Intersection ID: N/A	Main Street:	Cross Street: N/A	Location: N/A			
ADA ID: F80FA69D2AEF	Signal Type:One Push Button-APS	Overall Compliance: No	Severity Score: BTN 1:N/A	BTN 2: N/A	No BTN:	N/A
Codes/Mitigation Info/Possible Solution			Field Measurements/Component Compliance

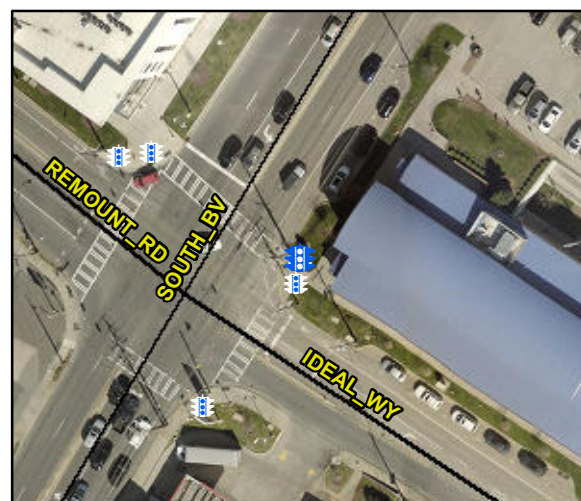
**PROW/ADA: R404.2, R404.3, R406.2, R209.1,
MUTCD 4e.10**

**Possible Solutions: Remove & Replace
Replace APS Button With New APS Button.
Remove and Replace Clear Space.**
